INNER WEST

DEVELOPMENT ASSESSMENT REPORT

Application No.	DA/2020/0359
Address	26 Florence Street, St Peters
Proposal	Torrens title subdivision of the existing lot into (2) lots and construction of a dwelling on each lot.
Date of Lodgement	14 May 2020
Applicant	ANJ INVESTMENTS PTY LTD c/o Blu Print Designs
Owner	Waste 360 Pty Limited
Number of Submissions	14 unique (including 1 petition)
Value of works	\$855,000.00
Reason for determination at Planning Panel	Number of submissions (10+)
Main Issues	Car parking, overshadowing and view loss
Recommendation	Approval with conditions
Attachment A	Recommended conditions of consent
Attachment B	Plans of proposed development

Figure 3: Context map for view loss assessment.

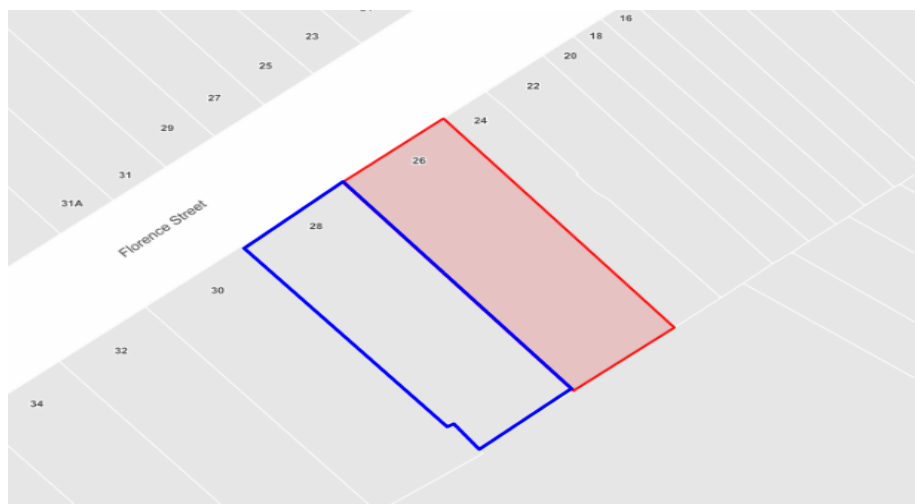
As the MDCP 2011 does not include a specific part relating to view loss, Council relies on the Planning Principles relating to view sharing established by the New South Wales Land and Environment Court (NSW LEC) in *Tenacity Consulting v Warringah Council* [2004] NSWLEC 140 to assess view loss impacts. The following property has listed view loss as part of their submission to Council:

- 28 Florence Street, St Peters.
